LAND EAST OF:
DROVE LANE
YAPTON

.....
DESIGN & ACCESS STATEMENT

...Addendum

September 2021

Figure 7: Amended Materials/Character Area Plan

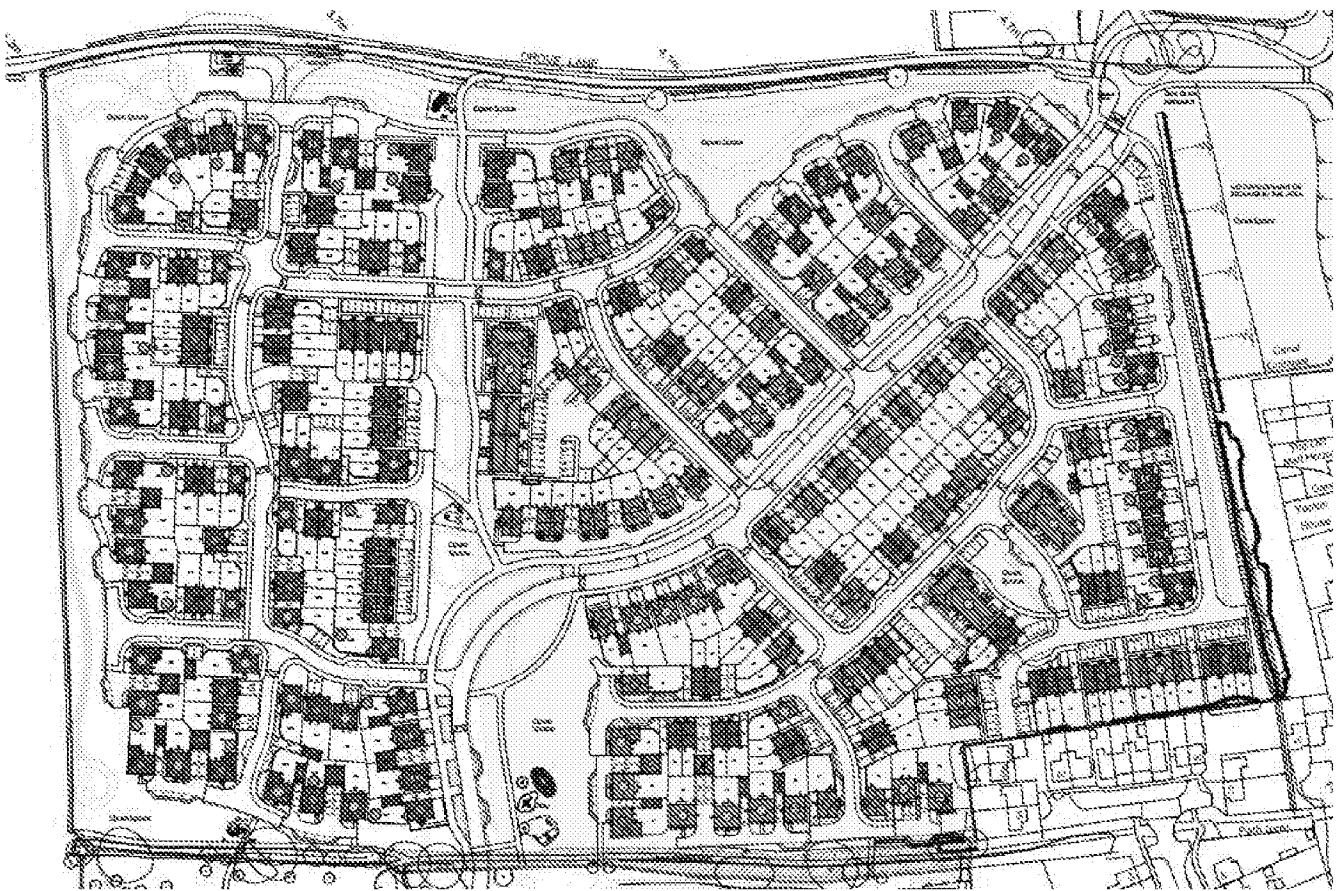
- 3.11 Most building elevations are as before, with the exception of the affordable dwellings which have been updated to ensure the scheme is tenure blind. The boundaries between character areas have been amended to better reflect the Approved Design Code.
